From: Shreekant Patel
Sent: 06 September 2023 09:46
To: Kwaku Bossman-Gyamera
Subject: HGY/2023/2231 - Pavement Opposite 214-218 High Road, London N15 5BT

Hello Kwaku,
Transport comments are as follows:

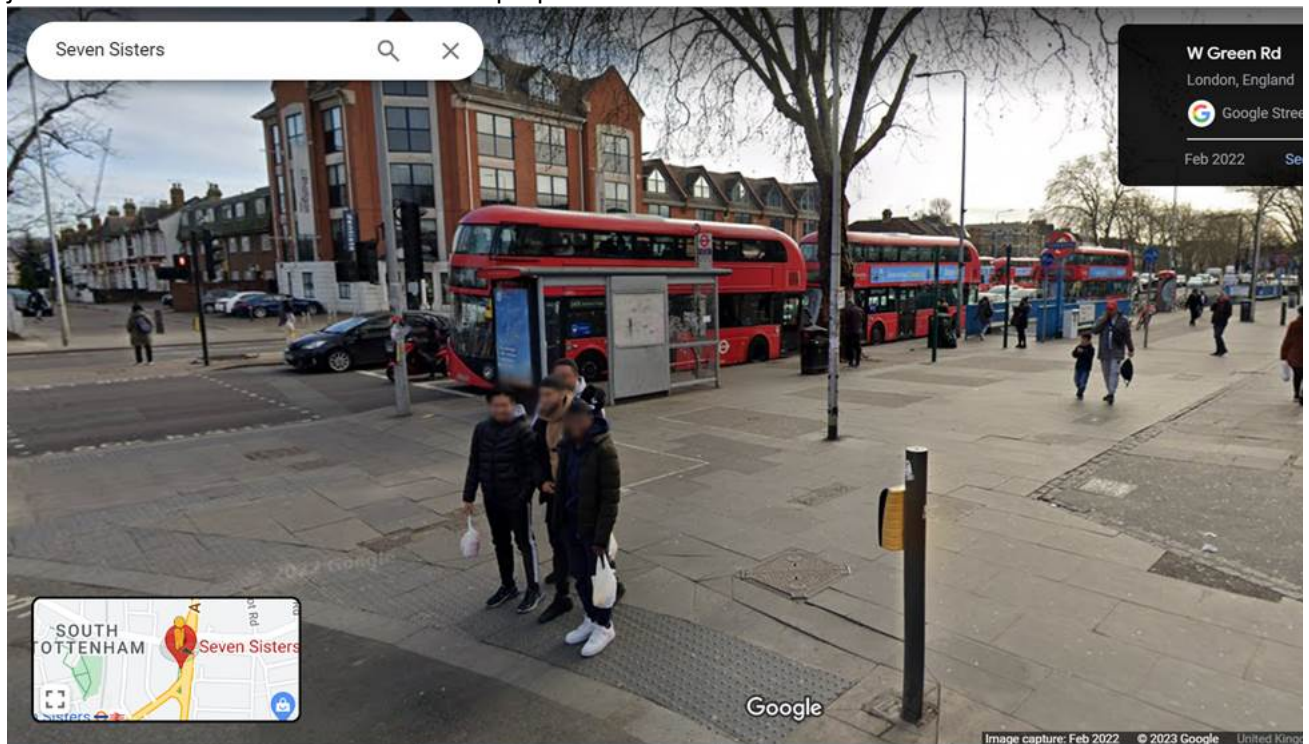
- a. The proposed installation of a communication hub with digital advertisement panel will adversely impact on pedestrian amenity by increasing street clutter along the footway.
- b. The location of the proposed communication hub with digital advertisement panel will increase the distractions for all road users given the proximity to a busy junction, pedestrian crossing, station entrance, bus stop with advertisement panel and cycle lanes. It should also be noted there is an existing telephone box just to short distance to the south of the proposal – see below.
